# Capturing Jitter Penalty During TDECQ and FRx Tests

**IEEE 802.3dj Plenary Meeting  
Vancouver**

**March 9, 2026**

Red Line for case of 2:1 Mux Jitter Doubling  
Blue 1:1 PMA-PMA Jitter Transfer

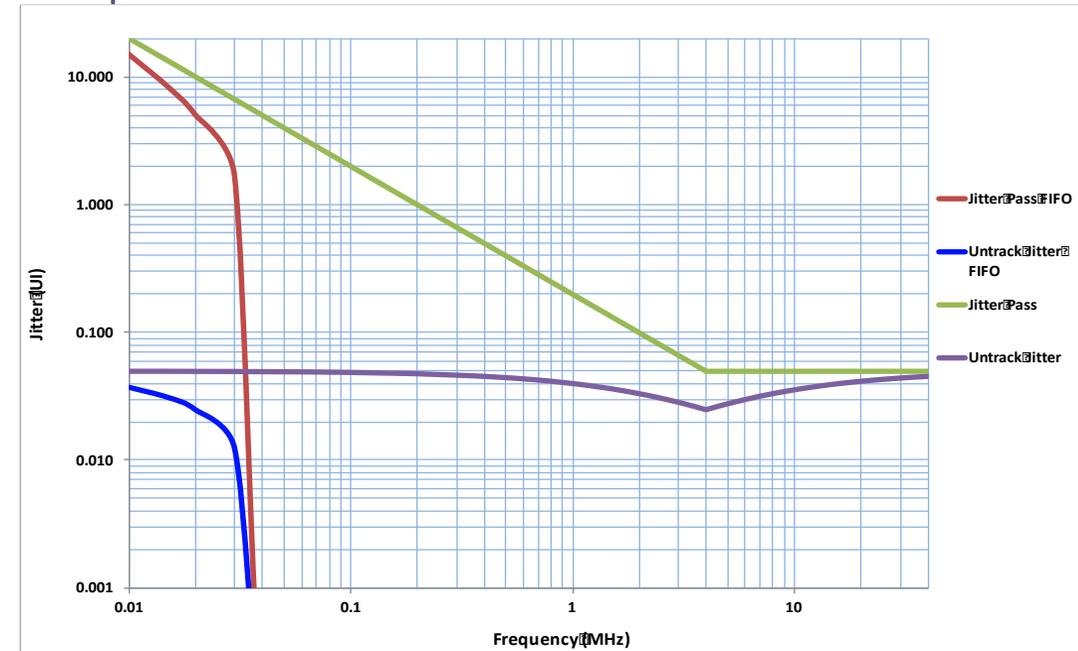
## □ PMA-PMA implementations such as BW, peaking, and FIFO has significant impact on jitter transfer

- With benign signal applied to xAUI-n penalties to jitter from xAUI-n and jitter peaking are masked from TDECQ/FRx
- For detail of jitter transfer graphs below see [ghiasi\\_3cd\\_01\\_0118](#).

Table 176D-12—Receiver jitter tolerance parameters

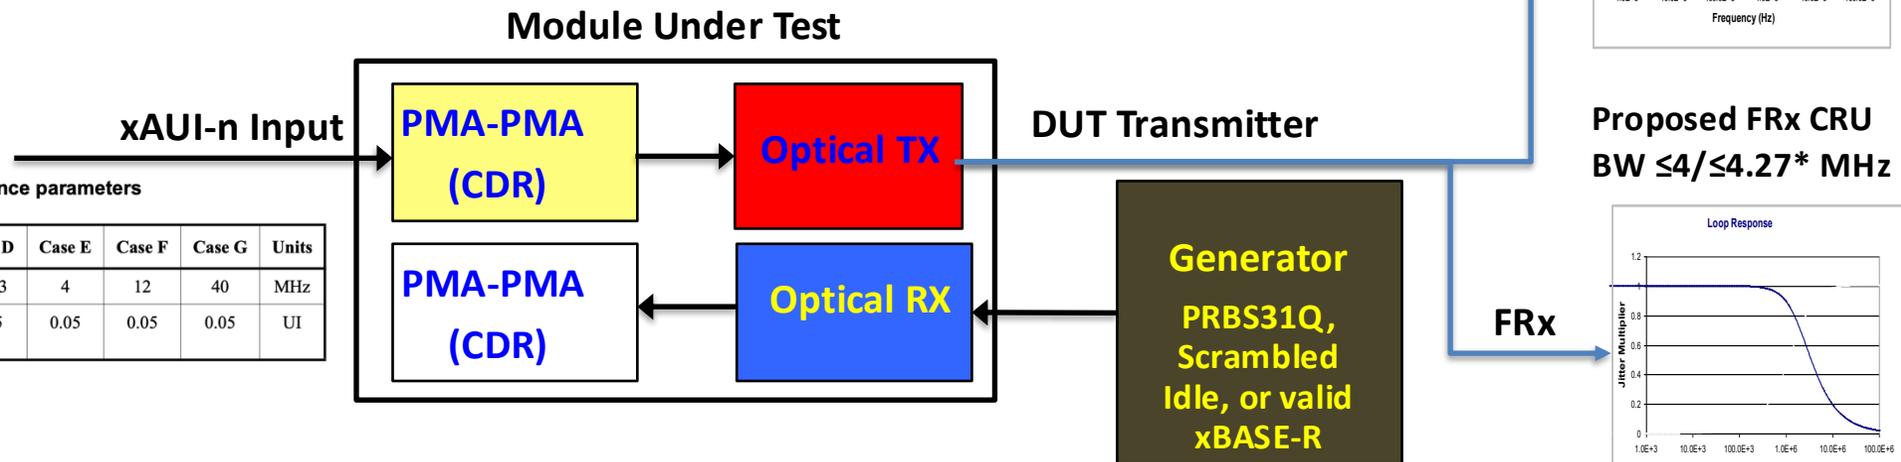
## Module under test TECQ/TDECQ and FRx results are depended on how well DUT test setup captures worst case allowed jitter

- The highlighted module PMA-PMA may have variety of responses worst case input jitter present:
  - May have BW <4 MHz – AUI receiver may fail and result in errors in input stage that can be caught by FRx
  - May have BW ≥4 MHz – AUI has excessive tracking by passing excessive jitter but TDECQ and FRx expect to catch
  - Excessive CDR peaking – some input jitter gets amplified but TDECQ and FRx expect to catch
  - In case of 2:1 PMA integrated jitter may double - but TDECQ and FRx expect to catch
  - May include FIFO where xAUI-n jitter is attenuated – class of PMA less sensitive to input jitter
- Dependeding on the module TX PMA design excessive jitter at TP2 may be generated for worst case xAUI input !

## Proposed Remedy See comments 124, 125, 126, 127, 128

- ❑ **Add following sentence to include JTOL test condition to 180.9.6, 180.9.9, 181.9.6, 182.9.6, 183.9.6**
  - For those cases there is a xAUI-n chip-to-module (C2M) interface TDECQ must be met with Module stressed input condition in 176D.8.14 for 200 Gb/s AUI and in 120G.3.4.3 for 100 Gb/s AUI
- ❑ **The proposed remedy did not want to require testing at all 8 JTOL test frequencies**
  - Generally, for a given DUT PMA/Module one of the JTOL frequencies may result in maximum penalty at TP2
  - Manufacture may choose to test at one frequency or may determine even testing without the JTOL condition present for a specific PMA-PMA device there is negligible jitter transfer penalty .
